CANYONS SOUTH FILING NO. 3
PROPOSED SANITARY SEWER AND WATER PLANS
SITUATED IN PORTIONS OF SECTION 19 AND SECTION 30 IN TOWNSHIP 7 SOUTH,
RANGE 66 WEST OF THE 6TH PRINCIPAL MERIDIAN,
COUNTY OF DOUGLAS, STATE OF COLORADO
PROJECT NUMER CDXX-XXXX

FIRE REVIEW 12613

CANYONS SOUTH FILING NO. 3
SANITARY SEWER AND WATER PLANS
TITLE SHEET

Sheet T1	1 of 22
Date NOVEMBER 24, 2021

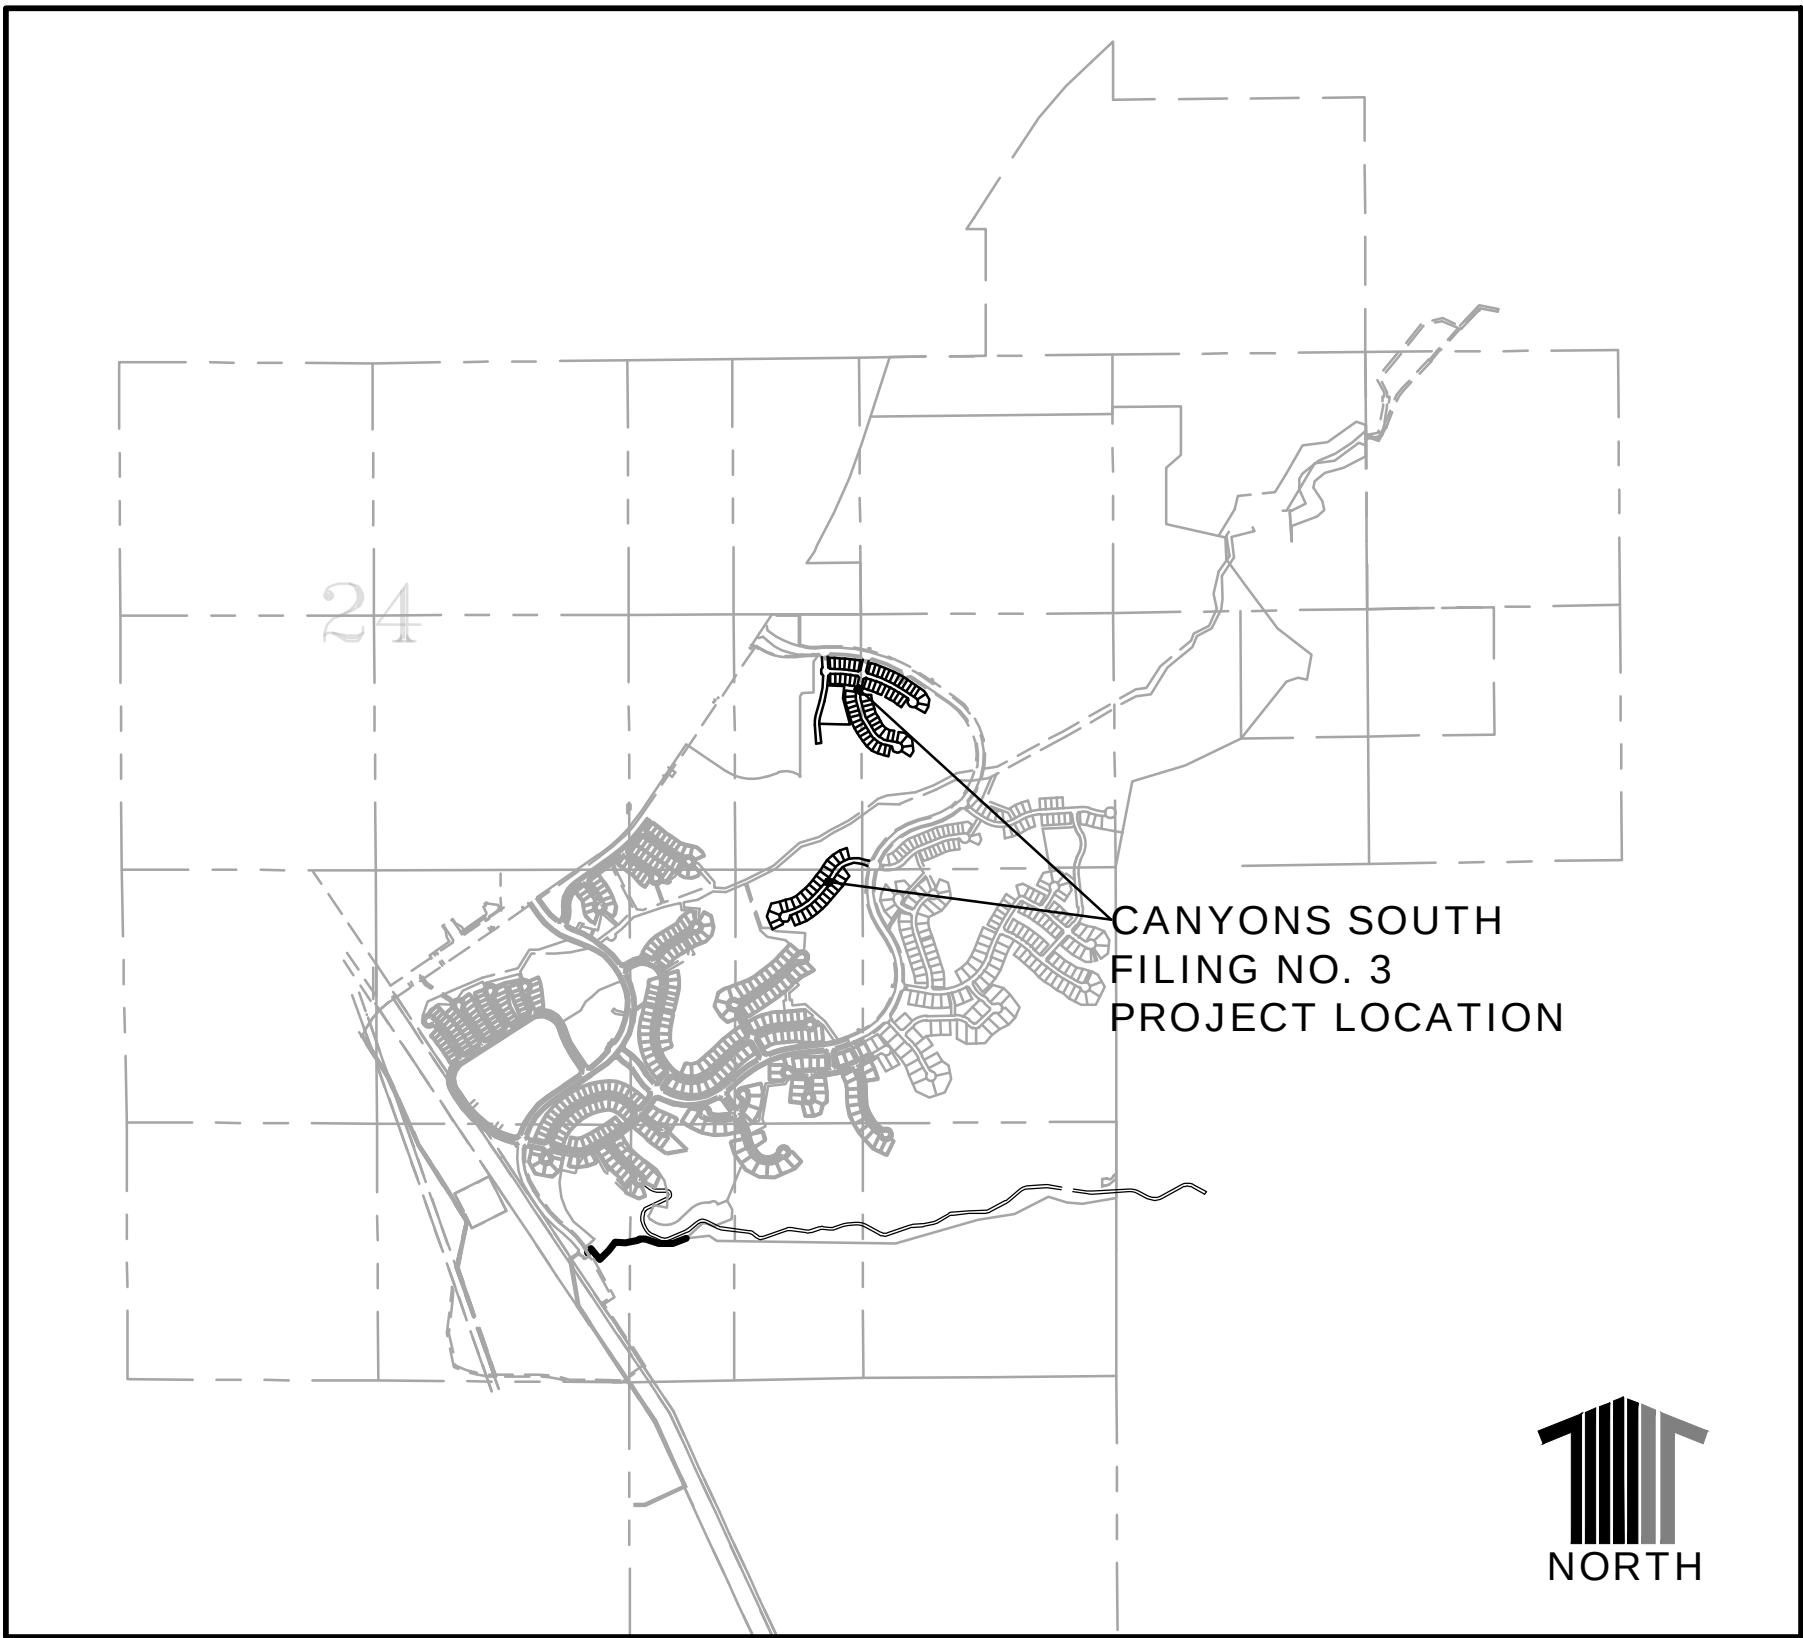
NOTE: DUE TO FIRE FLOW REQUIREMENTS, THE MAXIMUM SPACING BETWEEN FIRE HYDRANTS CANNOT EXCEED 450 FEET. PLEASE CHECK DISTANCES BETWEEN ALL HYDRANTS TO ENSURE DISTANCES. THERE ARE A FEW MEASURED EXAMPLES ON THE FOLLOWING PAGES.
